Re: Administrative Minor Modification Approval for: The Edge at Sunset
6075 Sunset Drive
South Miami, FL 33143
Folio No. 09-4025-011-0010

**Re: Sunset-Miami Investments, Inc. / Maestra Sunset, LLC / 6075 Sunset Drive
Request for Administrative Minor Modification review and approval per
Section 20-8.7.1 of approved Special Exception plan within TSDD.
Letter of Intent**

THE EDGE AT SUNSET
FOR:
MAESTRA SUNSET LLC
PROPERTY ADDRESS:
6075 SUNSET DRIVE
JOSE I. SAUMELL
AR0013085

DRAWN	CONTRACT DATE 02/02/2022
SCALE AS SHOWN	JOB NO. 2114.PRJ
SHEET TITLE: LEVEL 1 BUILDING PLAN	
SHEET NUMBER: A-2.1-ALT

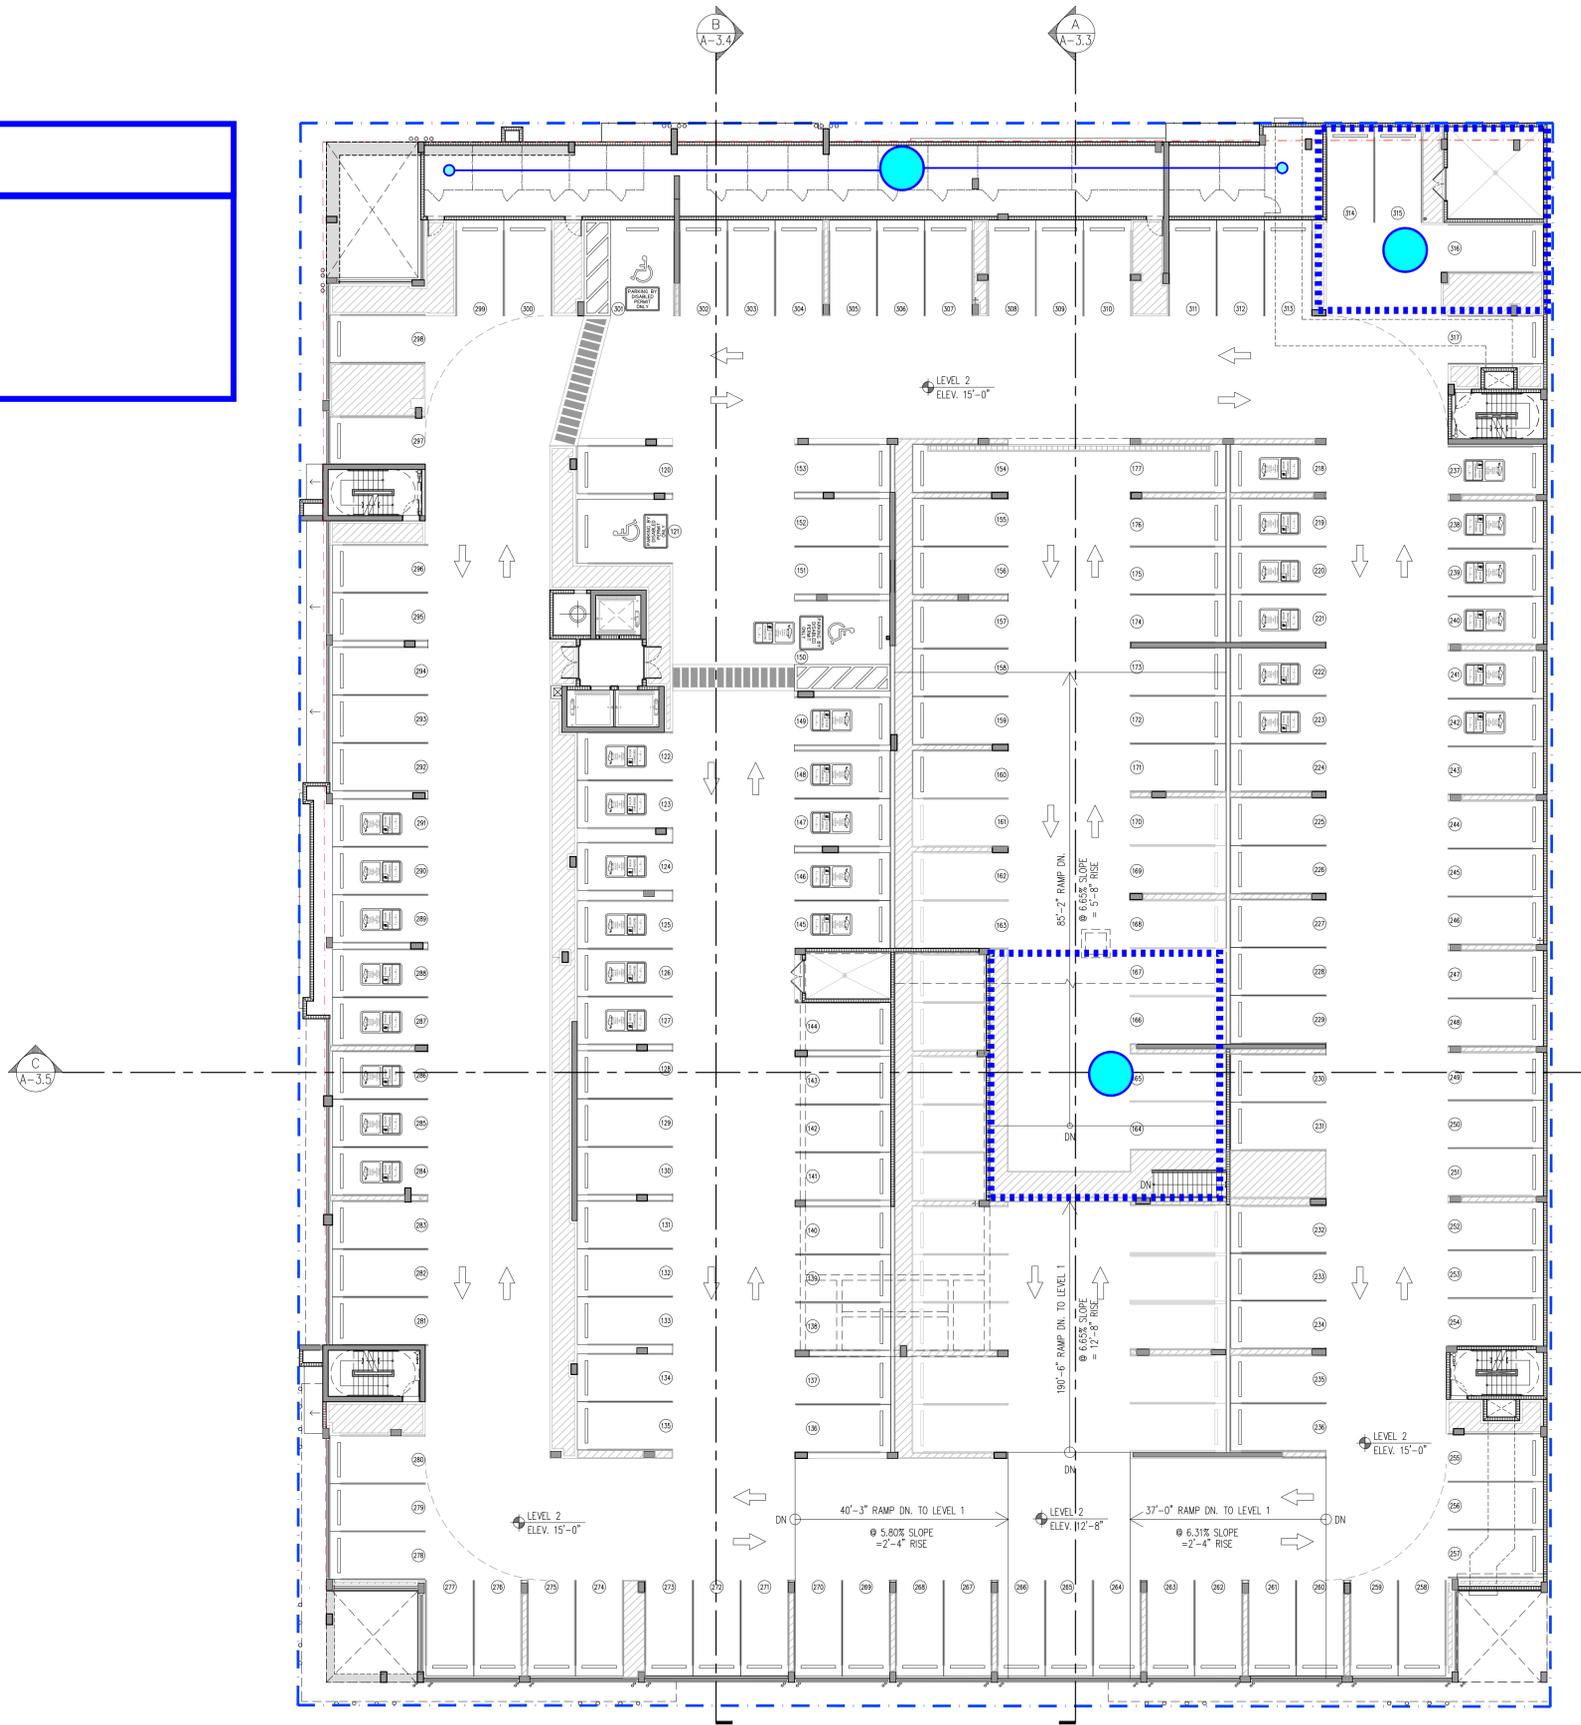
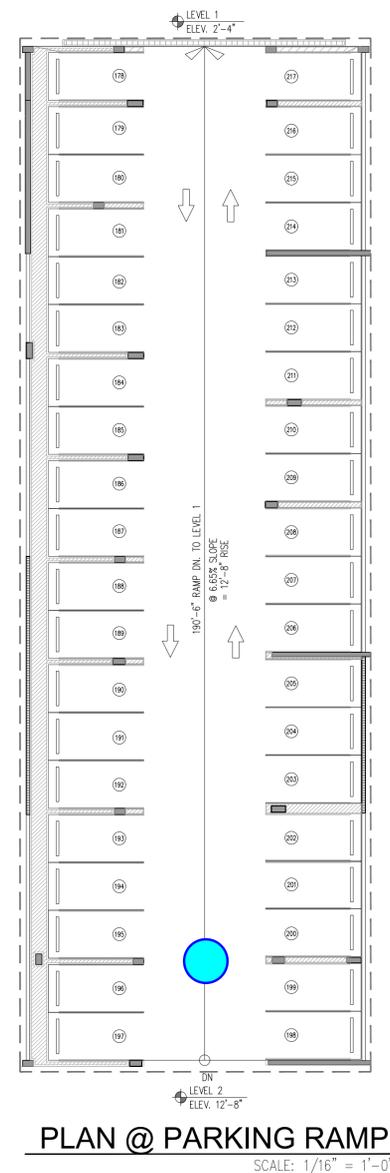
- ### NARRATIVE OF REVISIONS
- 1 ADD 200 SF OF OUTDOOR OPEN SPACE.
 - 2 ADD PLANTER BEDS ALONG SW 61ST AVE.
 - 3 ADD LANDSCAPE & TREES IN FRONT OF MAIN LEASING ENTRANCE ON SW 61ST AVE.
 - 4 ADD 1,500 SF OF ADDITIONAL RETAIL SPACE.
 - 5 ALIGN GARAGE VEHICULAR ENTRANCE WITH THE RAMP DRIVE
 - 6 INCREASE FPL VAULT SIZE PER FPL REQUIREMENTS
 - 7 ADDED OFFICES TO LEASING CENTER
 - 8 RELOCATED AND INCREASED MAIL ROOM
 - 9 ADDED PARKING SPACES
 - 10 ADDED MOVE-IN/STAGING ROOM
 - 11 INCREASE TRASH ROOM SIZE
 - 12 INCREASE LOBBY SIZE
 - 13 RELOCATE ELECTRICAL, PUMP, GENERATOR AND LOADING DOCK

DRAWN
CONTRACT DATE 02/02/2022
SCALE AS SHOWN
JOB NO. 2114.PRJ
SHEET TITLE:
BUILDING ELEVATIONS
SHEET NUMBER:
A-3.1-ALT

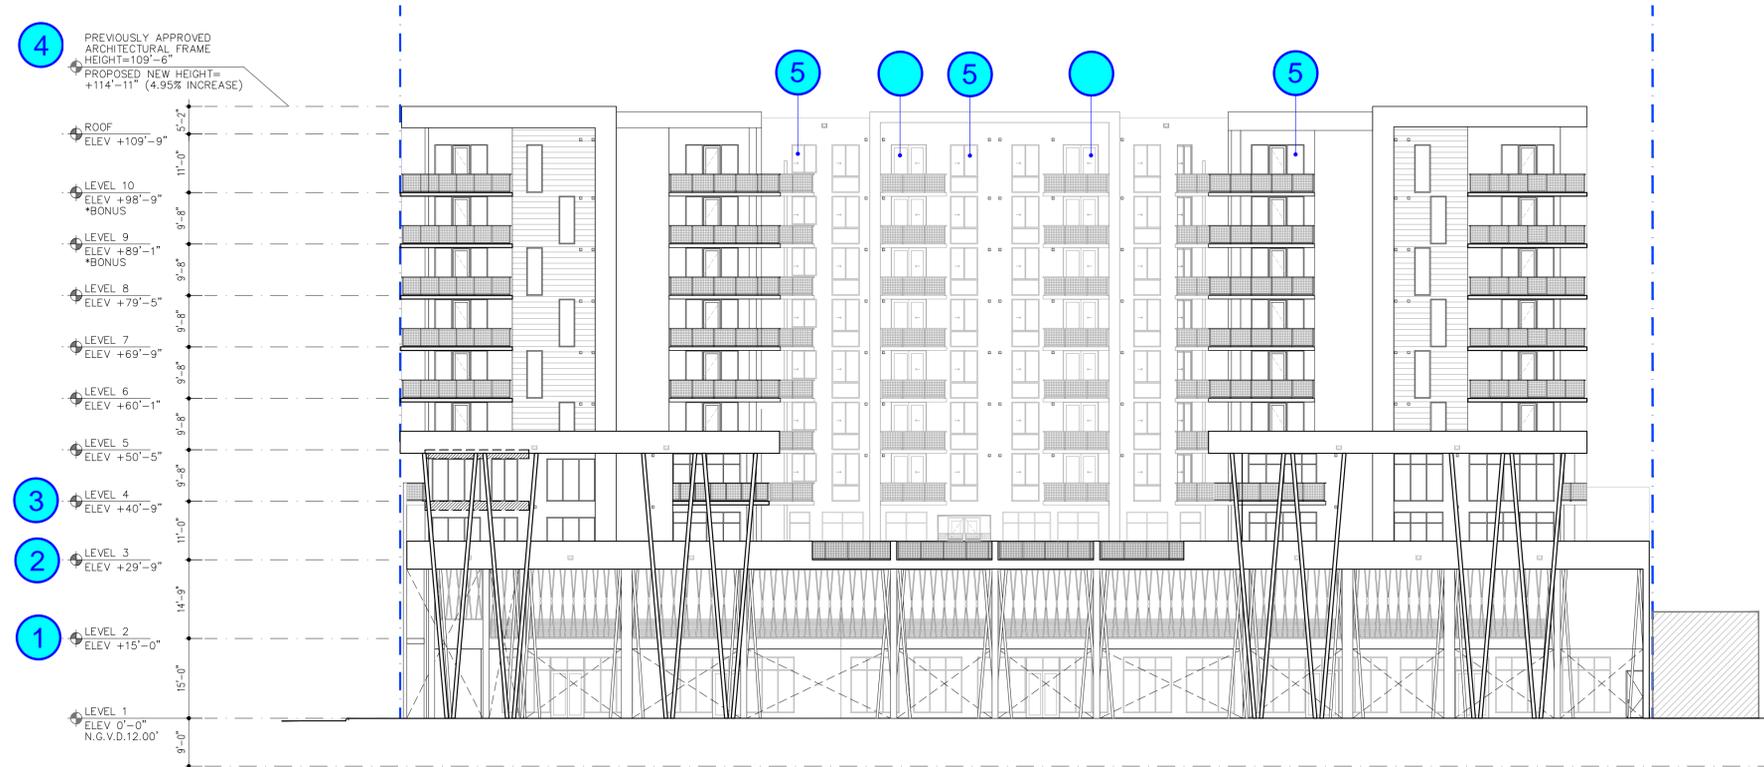
NARRATIVE OF REVISIONS	
1	INCREASE LEVEL 1 HEIGHT FROM 12'-8" TO 15'-0".
2	INCREASE LEVEL 2 HEIGHT FROM 9'-8" TO 14'-9".
3	INCREASE LEVEL 3 HEIGHT FROM 9'-8" TO 11'-0".
4	
5

DRAWN
CONTRACT DATE 02/02/2022
SCALE AS SHOWN
JOB NO. 2114.PRJ
SHEET TITLE:
BUILDING ELEVATIONS
SHEET NUMBER:
A-3.2-ALT

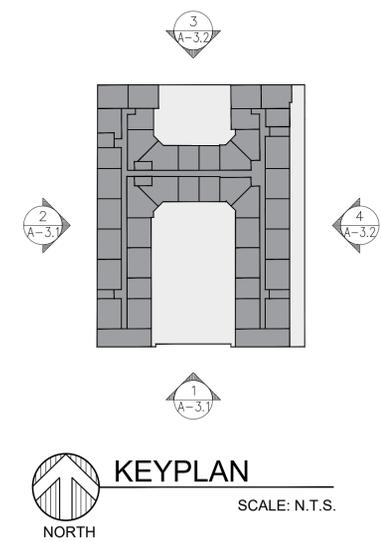
- 1 INCREASE LEVEL 1 HEIGHT FROM 12'-8" TO 15'-0".
- 2 INCREASE LEVEL 2 HEIGHT FROM 9'-8" TO 14'-9".
- 3 INCREASE LEVEL 3 HEIGHT FROM 9'-8" TO 11'-0".
- 4
- 5
